**Official Transcript of Proceedings**  
**NUCLEAR REGULATORY COMMISSION**

Title:                   Advisory Committee on Reactor Safeguards  
                              APR1400 Subcommittee: Open Session

Date:                  Monday, June 20, 2017

# 7.1 Introduction (Design Features)

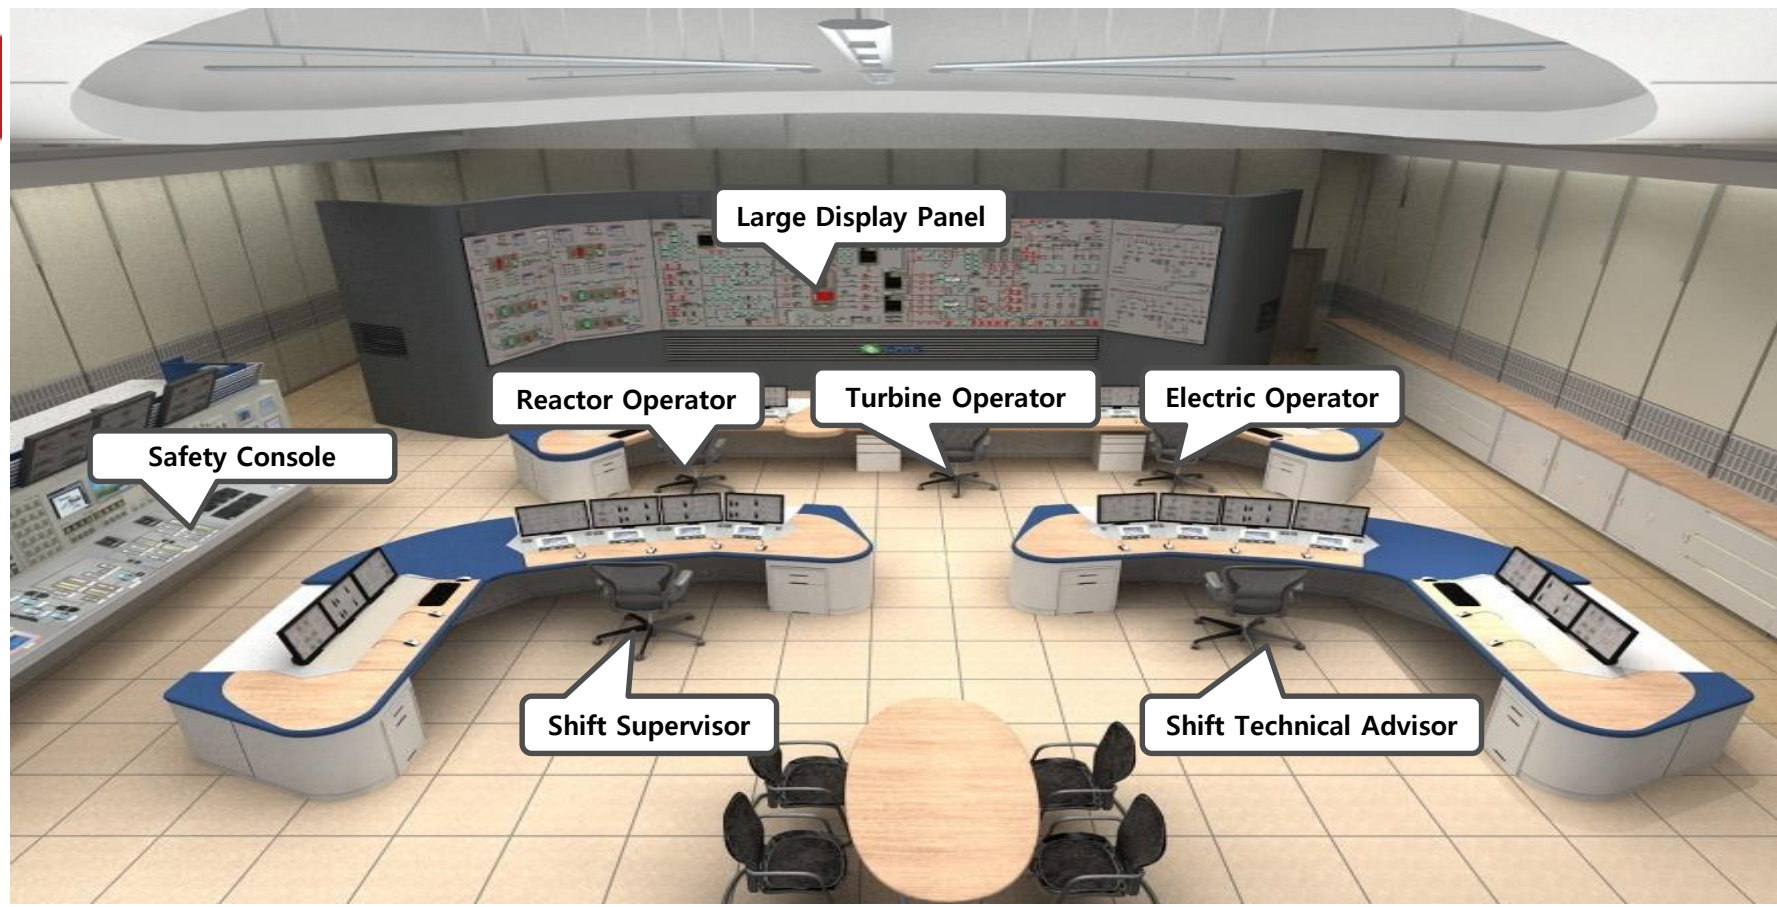
9 MEMBER BROWN: May I ask you a question  
10 before you switch slides? Are you switching slides  
11 or not? Are you staying on this slide for a minute?

13 MEMBER BROWN: Yes, I had a question.  
14 When you talked about the green color being dedicated  
15 equipment for the system, I'm trying to remember back  
16 when I was reading. Does that fundamentally mean they  
17 are not software-based systems? Aren't those largely  
18 analog or relays, contact switches, and stuff like that?

20 MEMBER BROWN: When you talk about the  
21 dedicated equipment for the CIM, the APCS --

18           MR. HECHT: My question is -- and it may  
19 not be the right time to ask this question and, if so,  
20 please let me know -- but the DCN-I network is a  
21 ethernet-type network, and it involves non-safety as  
22 well as diverse systems. Have you considered the  
23 cybersecurity defenses that might be necessary for such  
24 a system?

3 MEMBER BROWN: Okay. Let me amplify for  
4 a few minutes. It is relative to your figure here.  
5 And I had kind of the same question when I was going  
6 through this. It is one of the few areas where I had  
7 additional through processes or questions relative to  
8 my overall review.

15 MEMBER BROWN: For example, if you look  
16 at your figure, there is a reactor operator console,  
17 you know, the second one off from the left in your  
18 figure. That console will not take control of the  
19 electric plant? It cannot fulfill the functions of  
20 the electric operator? Is that true or not? I was  
21 hoping for a yes-or-no answer.

12 MEMBER KIRCHNER: Just a question of  
13 clarification: your labels obscure what display is  
14 available to each of the operators. Do they each have  
15 three panels showing the entire plant function?

6 MEMBER BROWN: Oh, I know what it was.  
7 On your diagram here you show blue lines, red lines,  
8 and some other kinds of network lines. And you show  
9 blue lines going up to the large display panel. You  
10 show blue lines going up to the -- I have to look it  
11 up -- the IFPD.

21                  Back to your big picture again, slide  
22 whatever it is, it is a really simple question. And  
23 I just probably got it wrong. Right there.

1 operator stations or monitors. The IFPD implies that  
2 it is just an Information Flat Panel Display, but there  
3 is a blue line that comes out of it that goes down to  
4 the DCN. And those stations all control plant  
5 function. So, I presume that overall IFPD  
6 configuration also allows control functions to be  
7 transmitted from each of those stations down to whatever  
8 needs to be controlled in the plant. Is that correct?  
9 And they go via the DCN.

22 MR. J. KIM: Yes. In case of the APCS and  
23 the CIM, this model is implemented by the analog  
24 devices.

1 about cybersecurity as well as the SSDOE plan during  
2 the design development. And also, we finished the  
3 evaluation for the vulnerability of the SSDOE, about  
4 the whole I&C system.

19 MR. RO: Yes, yes. Yes, yes, they can  
20 access the entire plant function, yes.

4 MR. J. KIM: That's correct.
